Groundwater Application Review Summary Form

Application # G- 19418

SUBJECT: Scenic Waterway Interference & General/Local Surface Water Evaluation for Deschutes Ground Water Study Area

TO: Water Rights Section Date 8/2/2024
 FROM: Groundwater Section Joe Kemper
 Reviewer's Name
 SUBJECT: Application G- 19418 Supersedes review of NA
 Date of Review(s)

Hydrograph One: Water level records for wells near Sisters. The change in water level elevation corresponds to traces of the Sisters Fault Zone and associated geologic structure.

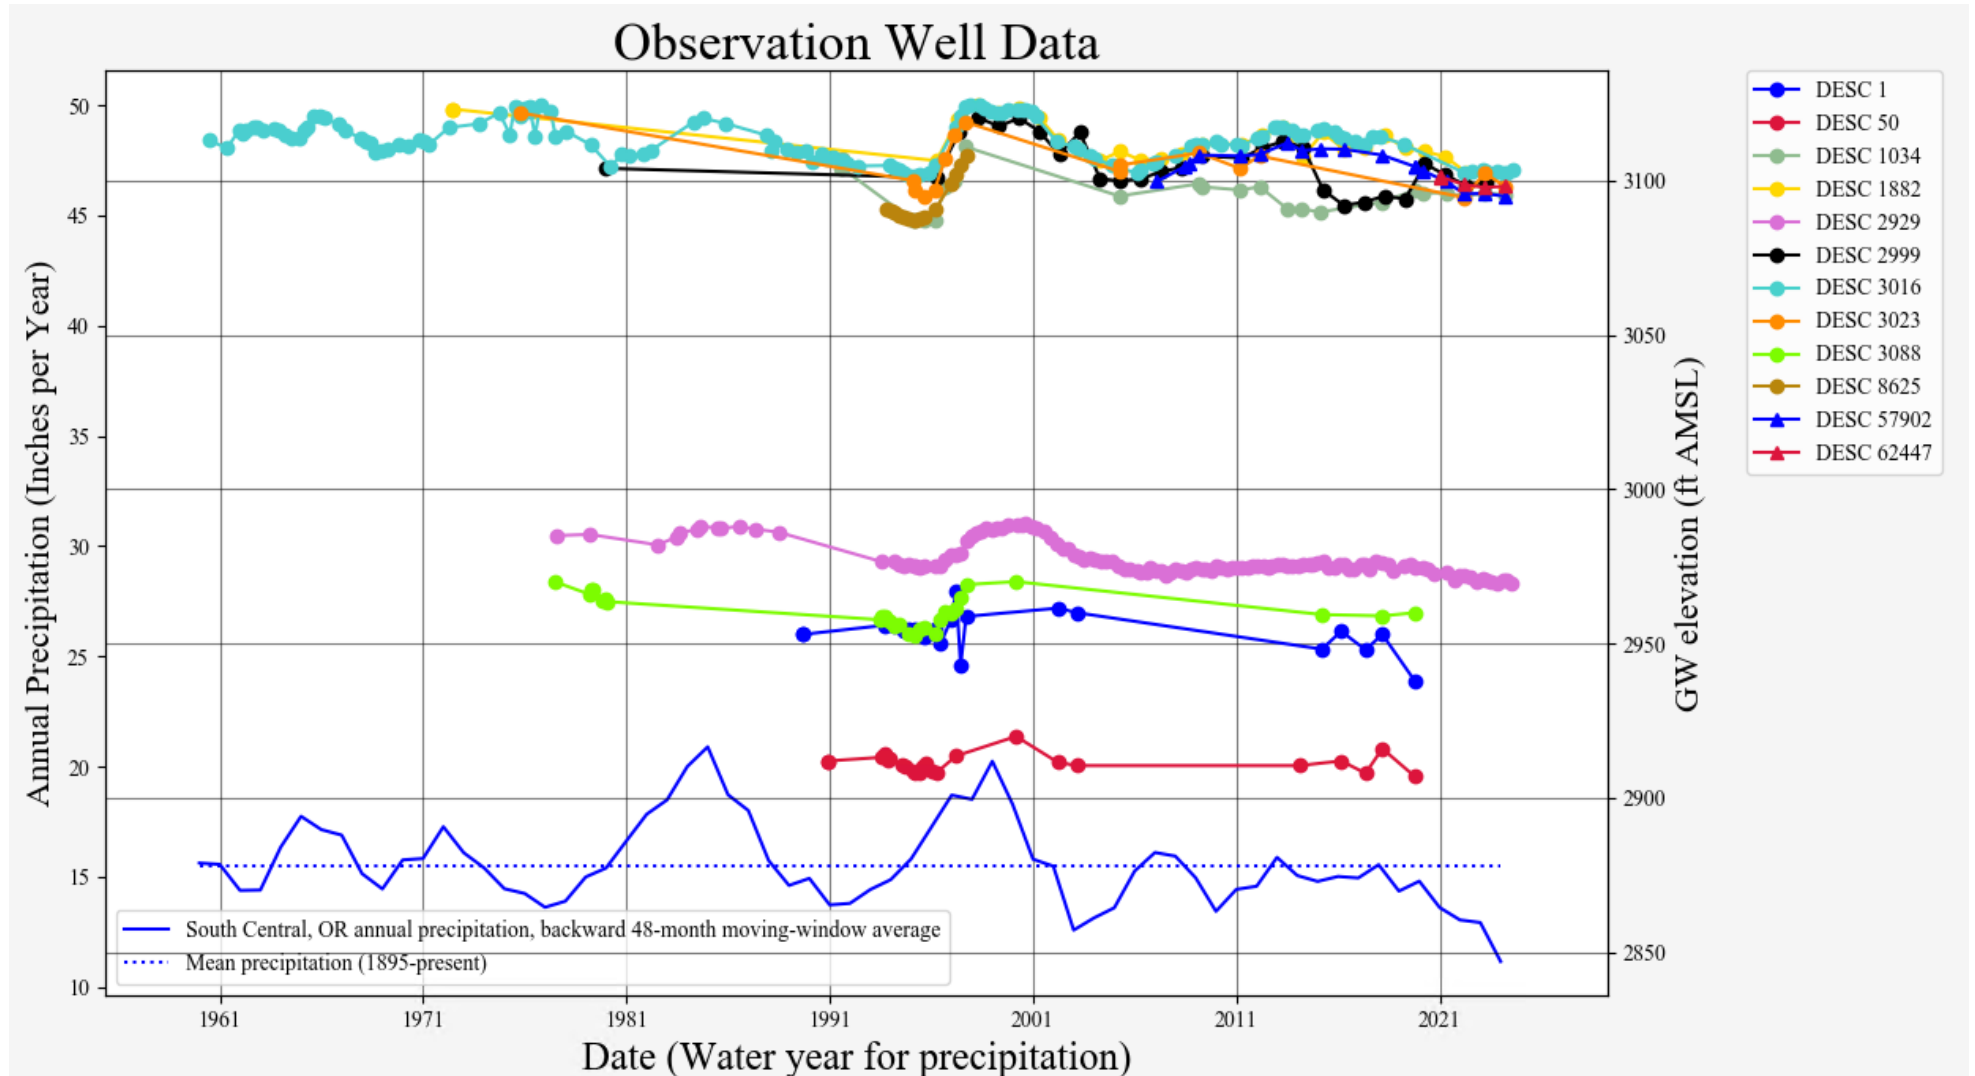
B3. **Groundwater availability remarks:** The applicant’s wells access the Deschutes regional aquifer where it is hosted by Deschutes Formation lavas and overlying glacial outwash sediments. Hydrograph one below shows a change in water level elevation that is coincident with traces of the Sisters Fault Zone and associated geologic structure. Upgradient (west) of the SFZ extent, water levels are approximately 3090-3120 feet AMSL. DESC 3016 has the longest record of the target aquifer zone, which appears to be in dynamic equilibrium with decadal scale climate fluctuations. Assuming that those decadal scale wet-dry periods will continue, water levels at this location will likely recover from their current lows with the onset of wetter-than-average years. At present, the target aquifer in this location does not have persistent year-on-year declines that raise issues of capacity of the resource issues elsewhere in the basin. It is noted that DESC 3016 also shows longer term declines that may reflect century-scale climate trends that are not as well documented.
